# PlanGrid Task Report - Jul 8, 2025

Prepared by Stephen Tassinaro

Jul 8, 2025

M-250

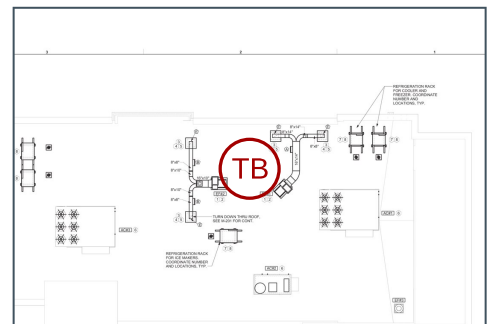
Access doors are not constructed properly in grease ductwork. EF-1 has a "C" sized door where it should have an "A". EF-2 has a "A" sized door where it should have a "C". Recommend discussing with

EOR and CFA to make sure  
this is acceptable.

### #394 [CURT 505] [NEW] Air curtain remote switch installation.

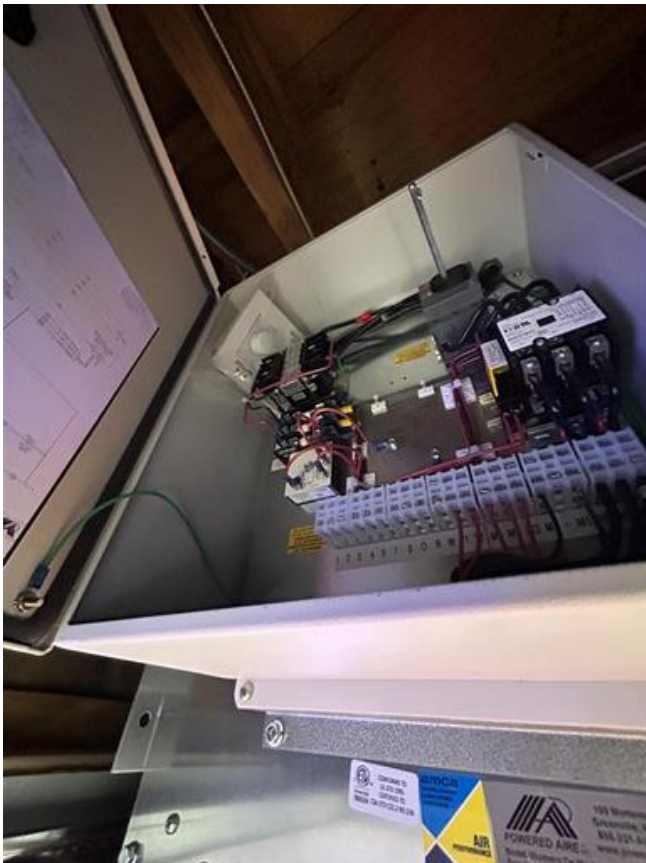
Air curtain remote switches are not installed or do not control curtain functions properly between modes (fan on / auto, heat on / off) at time of TAB inspection.

## #382 [UNIT 499] [NEW] CRITICAL - Equipment Condenser - RTU 3

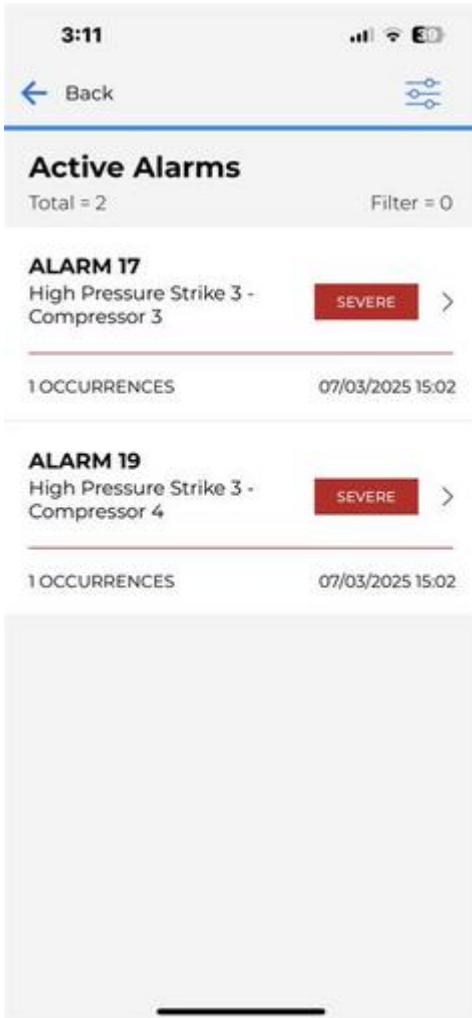
Unit not cooling properly, Unit alarms (High Pressure Strike 3-Compressor 3, High Pressure Strike 3-Compressor 4). Units supply temperature is 71 degrees.

**Sheet**  
M-301

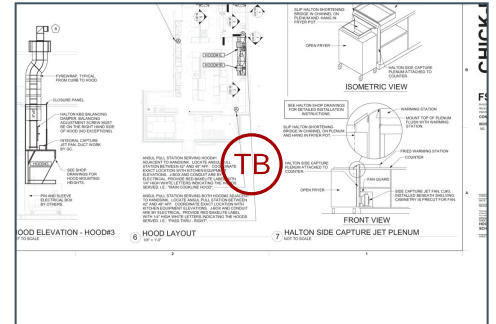
**Description**  
Label all ansul pull stations with bakelite labels per mechanical plans.
